Debris Intrusion into the Essential Service Water System

Cook Screenhouse Forebay Response to Dual Unit LOOP – Potential for Debris Intrusion in ESW System

Work Product Type: Vendor Technical Report
Work Product Number: NTS-2002-025-REP, Rev. 0
Title: "Cook Screenhouse Forebay Response to Dual Unit LOOP – Potential for Debris Intrusion in ESW System" prepared by MPR

Document No.: Report NTS-2002-025-REP, Rev. 0	Revision: 0	CS NO: N/A
Title: "Cook Screenhouse Forebay Response to Dual Unit LOOP – Potential for Debris Intrusion in ESW System" prepared by MPR		Attachment 1 to OAR Page: 1 of 3
This form was completed using the Calculation Review Checklist from 12 EHP 5040 DES.003

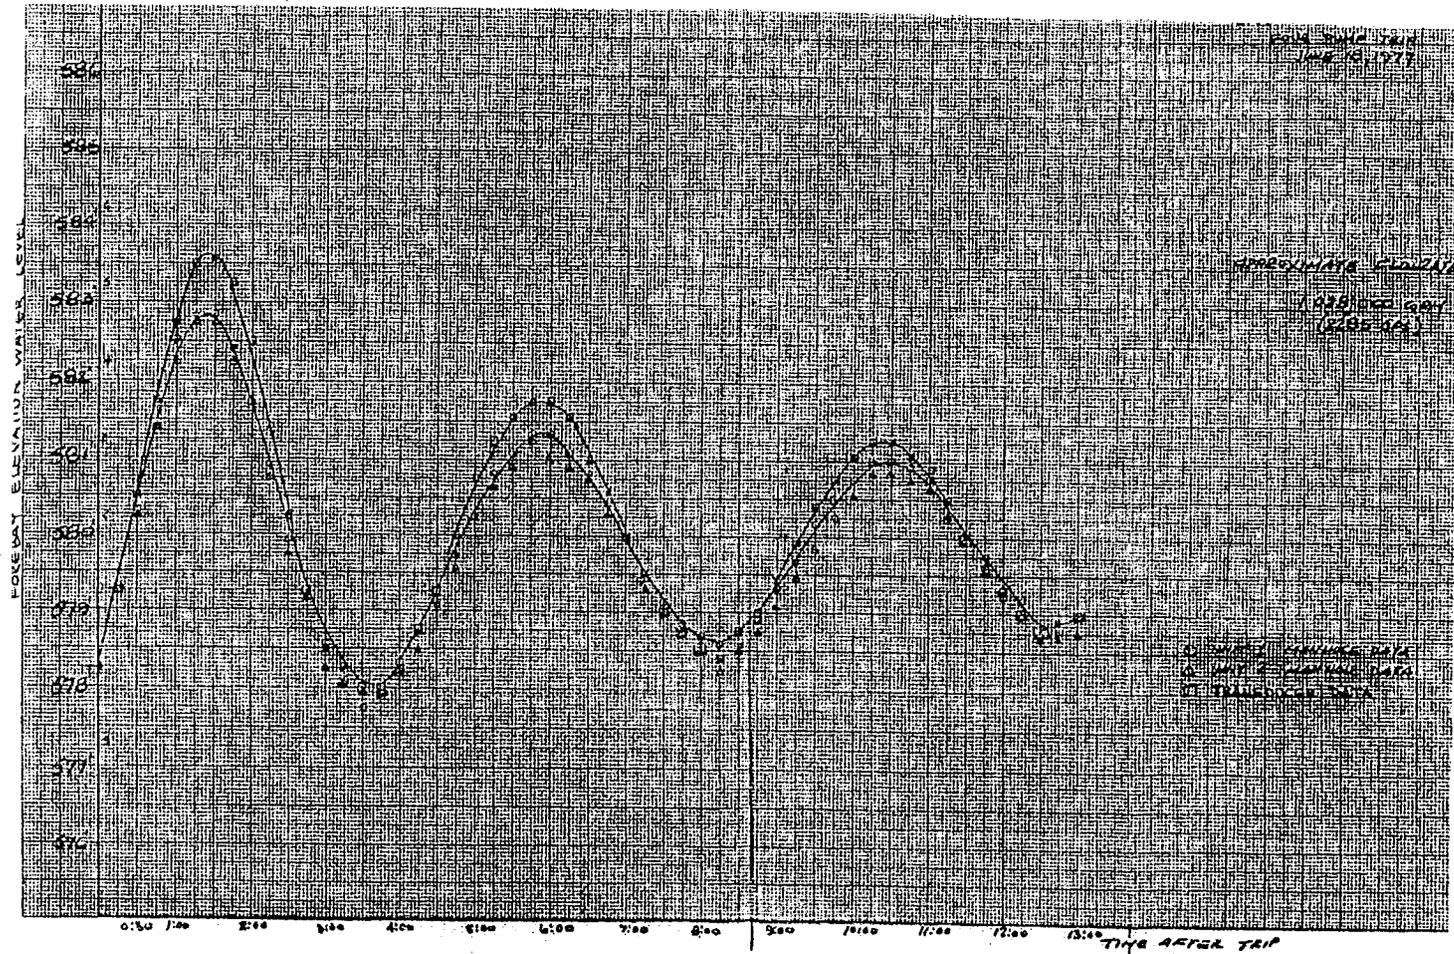
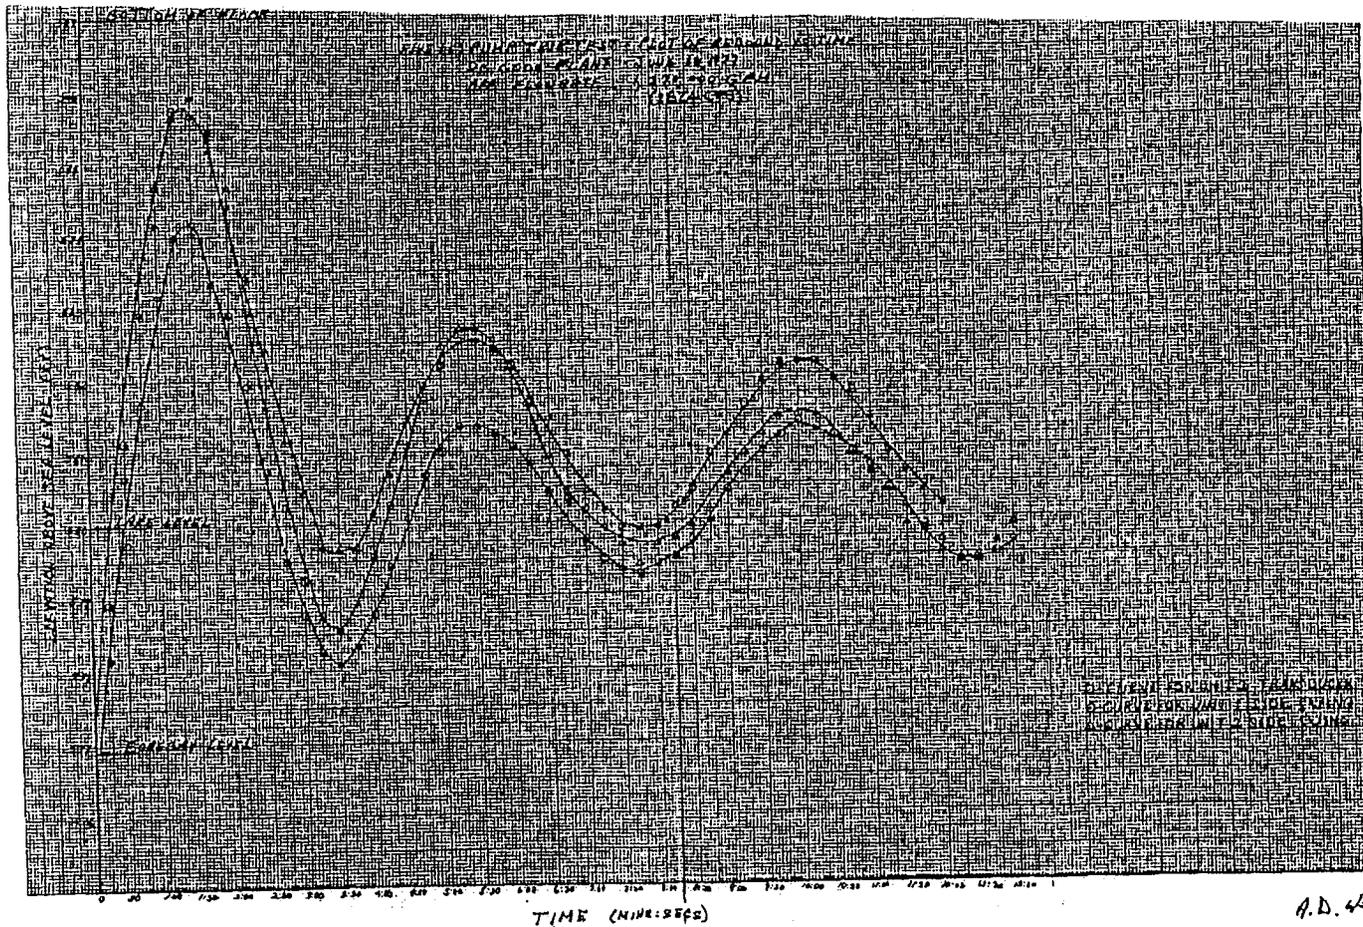
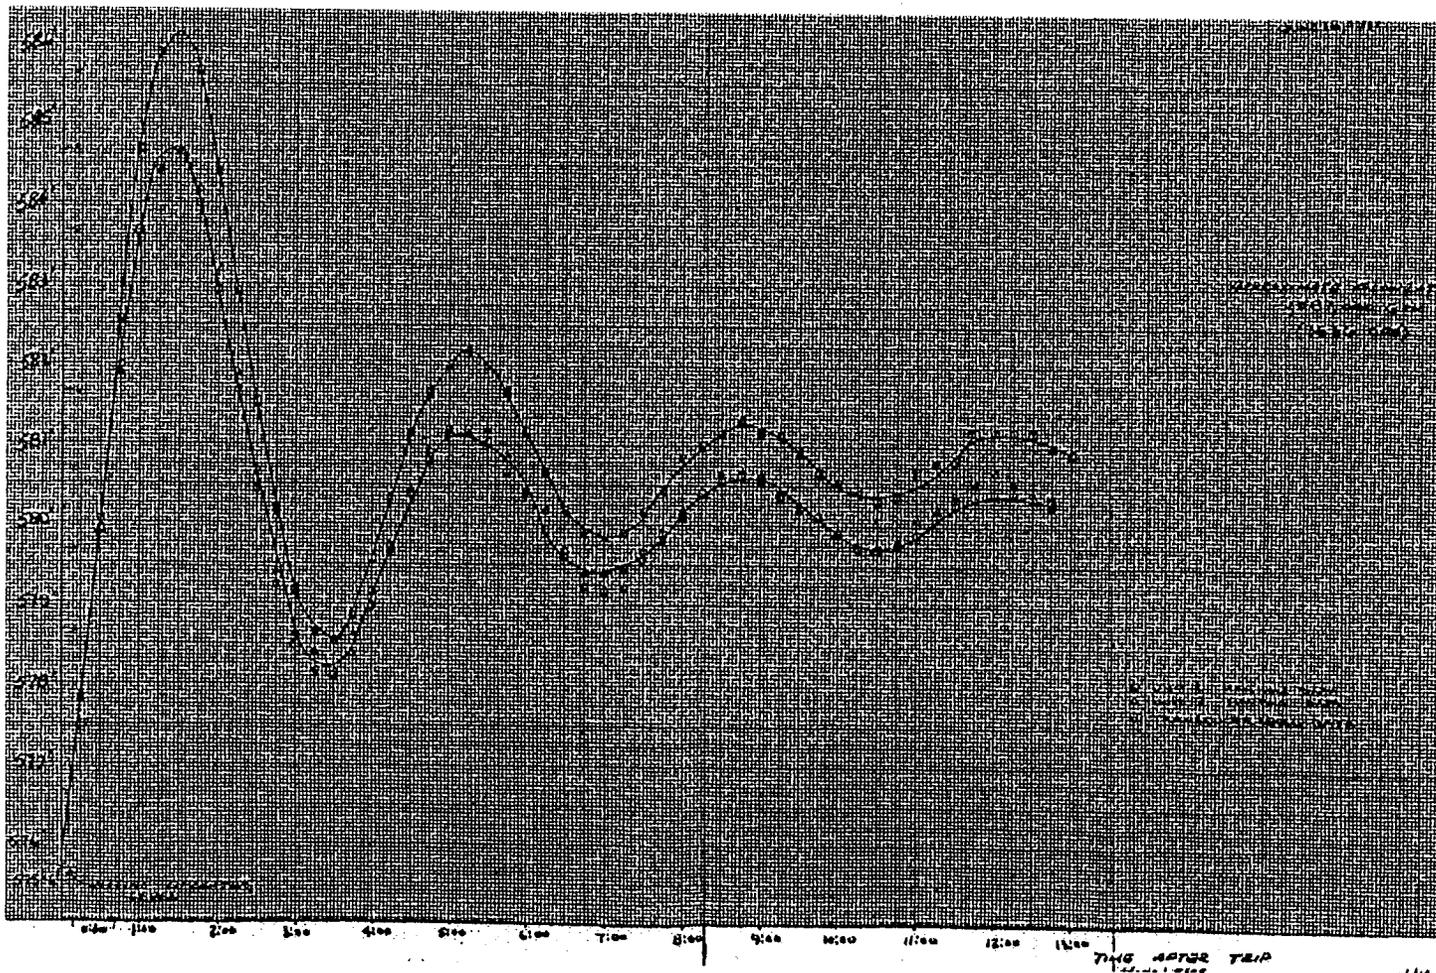
ATTACHMENT A	
8		Provide a discussion as to why the test performed in 1977 can be used to validate a model prepared for LOOP, considering the pump outlet valves would have closed during the test but remain open following a LOOP	Whether the discharge valves are open or closed, the hydraulic resistance between the forebay and the lake going through the condenser is significantly higher than the resistance of the intake tunnels (there is practically no resistance in the intake tunnels). As a result, the flow through the intake tunnels for a given forebay water level is much greater than flow through the discharge. Thus, the overall water level is determined primarily by the intake tunnel flows, and is affected only minimally by the discharge flow. This was confirmed in scoping analyses considering the effect of how rapid the CW pump coast down. Changing the coast down from 10 seconds to 60 seconds had only a small impact on the time to reach the maximum water level or the height of the water level.

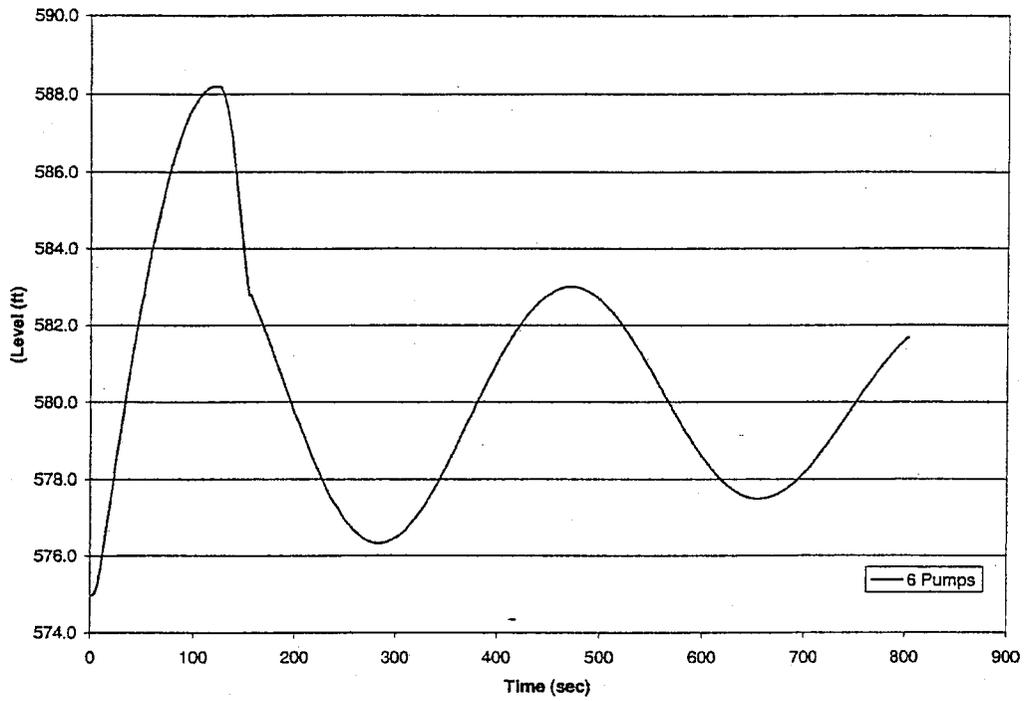
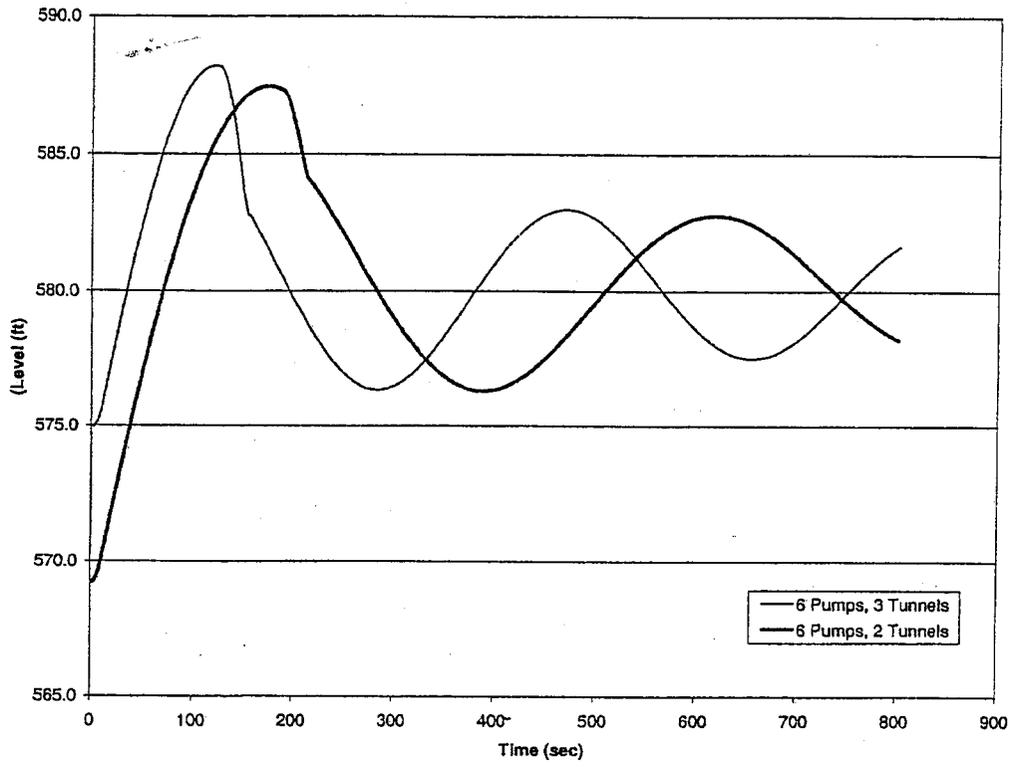
4		Maximum rate of rise in the forebay is stated as .15 ft/sec – data suggests it is more like .25 ft/sec.	The value of 0.15 was intended as an estimate of the bulk vertical velocity. A detailed review of the model results shows the actual value is 0.19 ft/sec. This does not affect the overall conclusion that the rate of rise is the same for two tunnels or three tunnels.
5		Provide basis for how 130 seconds was determined for duration of maximum fill for 2 intake tunnel case	The 1977 test data showed the maximum level occurs at about 90 seconds for three tunnels. The model predictions show the two tunnel case takes about 50% longer than the three tunnel case. 130 seconds is about 50% longer than 90 seconds.
6		pg 12 – flowrates in 3 rd paragraph are indicated as velocities	This is a typographical error.
7		pg 12 – It is stated that the debris will settle in about 2 minutes, but goes on to say that debris ingestion is eliminated within 1 minute – explain.	The calculations determined the settling time to be about one minute. Two minutes was selected as a bounding value to include any potential air foil effects that would slow down the settling.
